INITIAL DRAFT TAR NC NON-CONFIDENTIAL RESPONSES TO CONSULTATION

WHAT HAPPENED? On 30 May 2014, ENTSOG published for public consultation the Initial draft Network Code on Harmonised Transmission Tariff Structures for Gas (hereinafter ‘the initial draft TAR NC’) ⁽¹⁾. The Supporting Document ⁽²⁾ accompanying the initial draft TAR NC provided clarifications and explanations for the content of the initial draft TAR NC and encompassed 58 consultation questions on which the stakeholders were asked to provide their answers. The consultation period ran over 2 months and closed on 30 July 2014. ENTSOG received 46 responses out of which 1 response was marked as confidential. To facilitate the analysis of responses, ENTSOG asked the stakeholders to submit them via an online questionnaire.

WHAT IS THIS DOCUMENT? This document represents the compilation of all non-confidential responses received by ENTSOG which are structured in a reader-friendly format. Each answer is preceded by the contact details provided by the respondent. The responses are set out in the way they were provided to ENTSOG and are not accompanied by ENTSOG’s view thereon. This document has been prepared by ENTSOG for the co

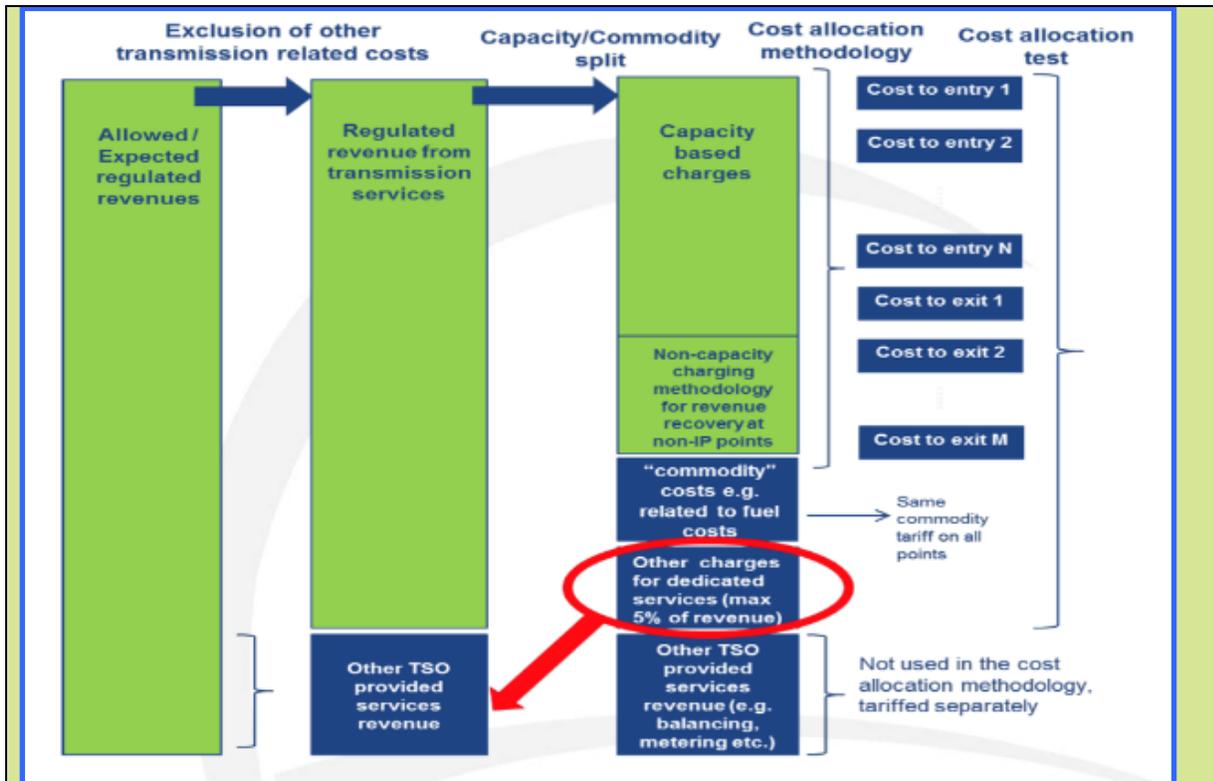
Figure 4 (above) shows how elements of the tariff payable by shippers are not adequately covered by the code. If *Other TSO provided services revenue* corresponds to those service elements introduced in Article 3.11 the code requires further elaboration of how such service costs are to be apportioned across users so that shippers can understand how their final payable tariffs are calculated.

Figure 4 confirms that the outcome of the *cost allocation approach* is a cost-pool for each of the relevant entry or exit points. How this cost pool is then used to derive the reference price is not clear in many of the methodologies. This is a gap in the articulation of the end-to-end process associated with several of the primary methodologies.

Figure 5: (Composition of allowed or target revenue and interaction between transmission services revenue and various charges)

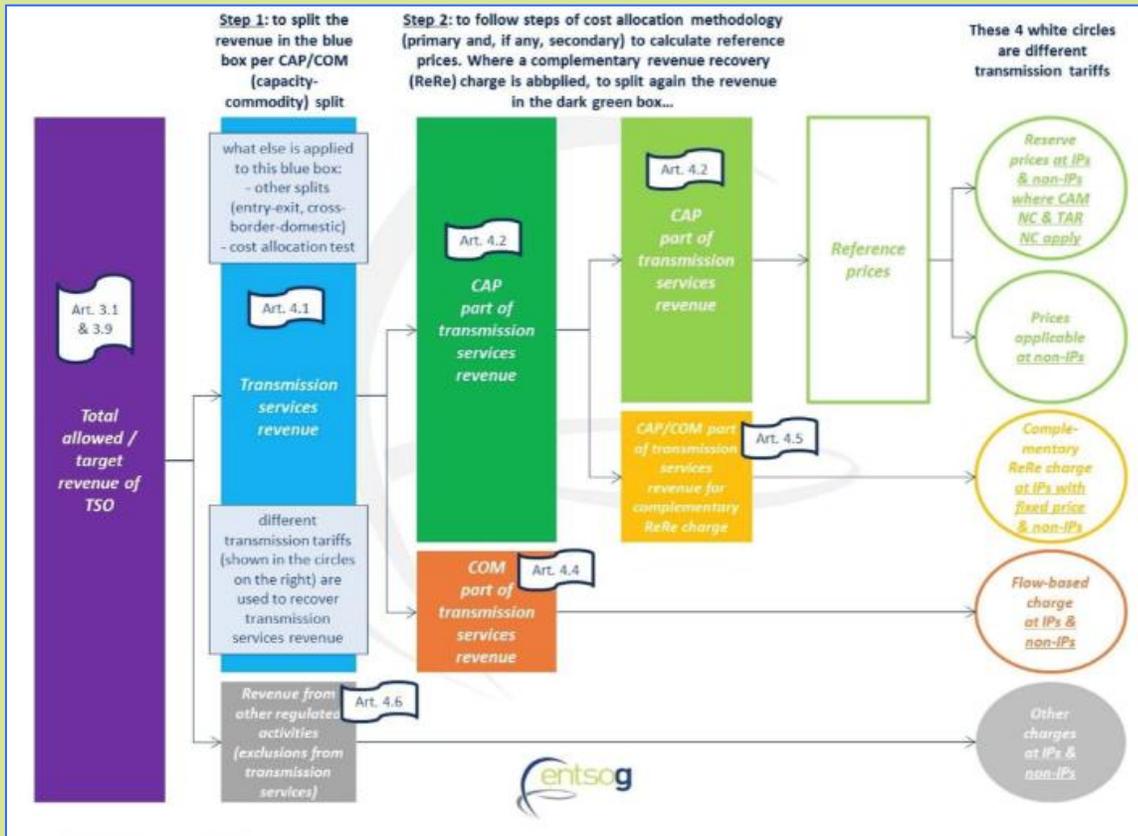
Figure 5 provides further details about the various tariffs that need to apply, many of which will require greater articulation in the code. That the third and fourth columns of the diagram feature two commonly labelled blocks (Article 4.2 CAP part of transmission service revenue) but of different sizes is testimony to the lack of clarity within the code in general and specifically within Article 4. A matrix describing the different charges would help clarity. The definition of each charge item is essential, together with a description of the class of points to which they apply, and the basis for charging should be established. Such a matrix should be established before the next release of the code to support understanding of the next version of the code. and is illustrated below:
